The Columbia Historic Zoning Commission will meet on Wednesday, January 17, 2024 at 4:00 PM in Council Chambers on the basement level of City Hall, 700 N. Garden Street, to consider the following:

Historic Zoning Staff Report

ADA REMODEL GLOVER SECOND HAND
1200 S HIGH STREET, COLUMBIA TN 38401

NOVEMBER 13, 2023
A-2
ADA RAMP DETAILS

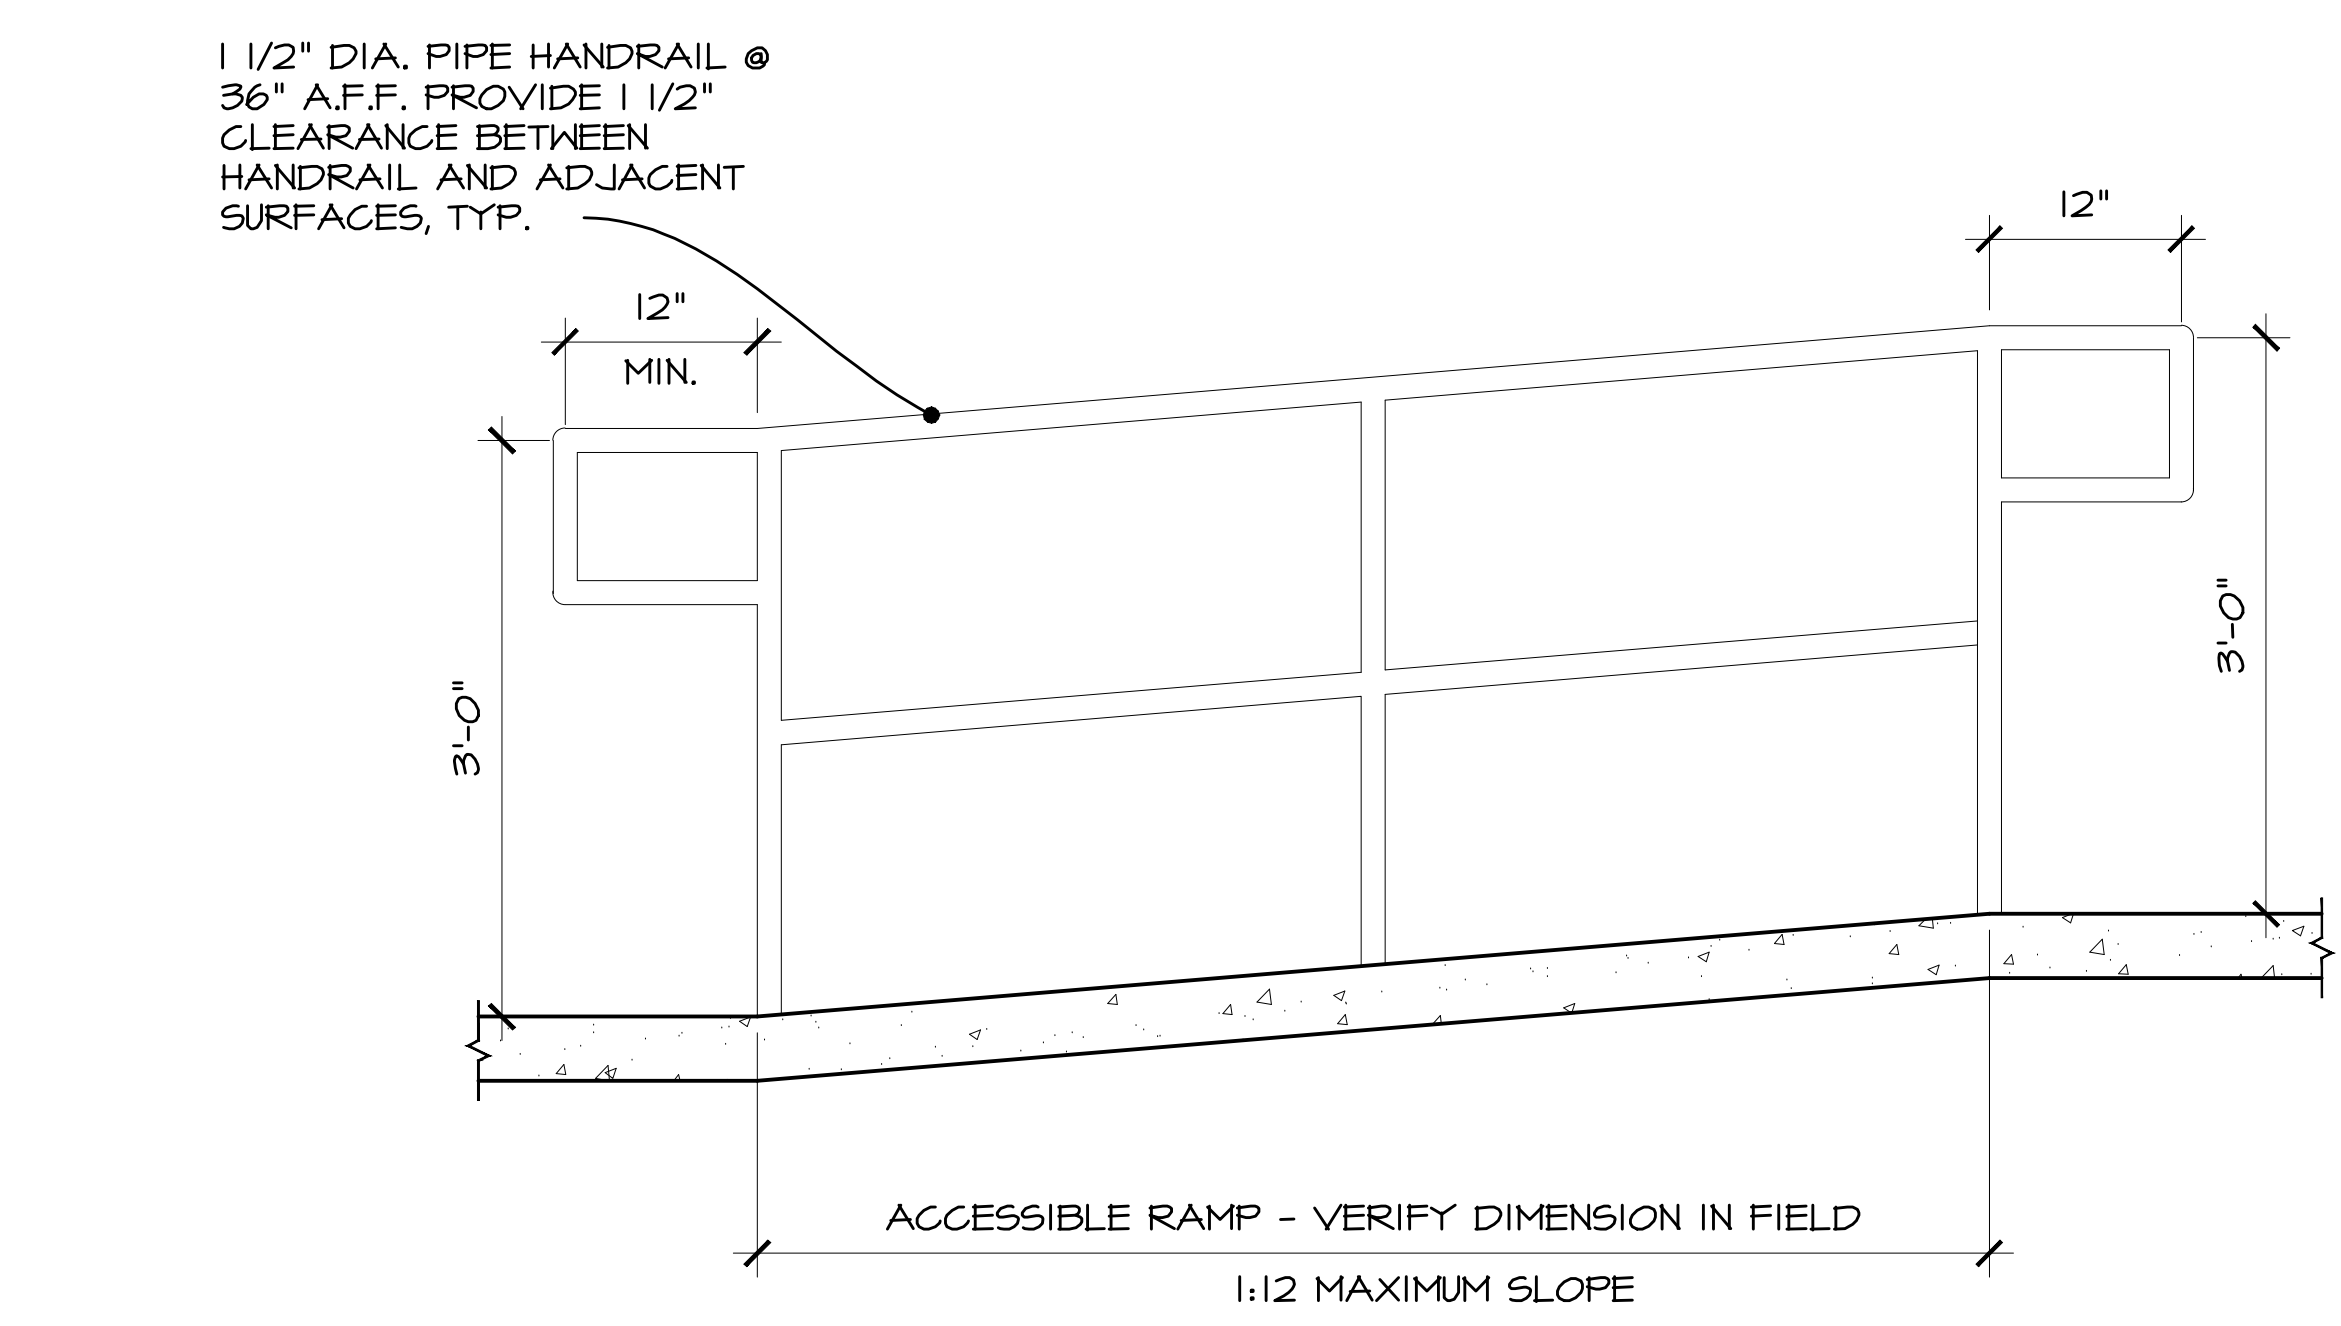
The proposed design submitted by the applicant is a typical handicap ramp design. The lot is situated on a corner with two frontages; South High Street and West 11th Street, with the primary entrance being located at the front of the structure parallel with South High Street. The proposed placement is the most appropriate location providing direct access to the establishment for persons with limited mobility. The lot configuration is prohibitive of construction anywhere else on site. Attention should be given to the proposed features of the ramp considering the visual impact.

- **Piping material proposed for the handrail is prohibited per 7.22 (d). Staff suggests a more compatible material, subject to Commission determination, be a part of Conditional approval.**
- **The proposed ramp description indicates standard concrete face for ramp section that will run parallel with frontage on South High. Staff suggests the Commission consider adding a condition to the approval that the applicant clad the exterior face of the ramp with a more suitable material; such as brick face or stone face veneer, or other material Commission deems appropriate in order to soften the feature in the frontage.**

- Handrails is must be made of *[identify allowable material]*.
- The proposed ramp description indicates concrete face of the ramp section parallel with the frontage on South High must be clad with brick face or stone face veneer.
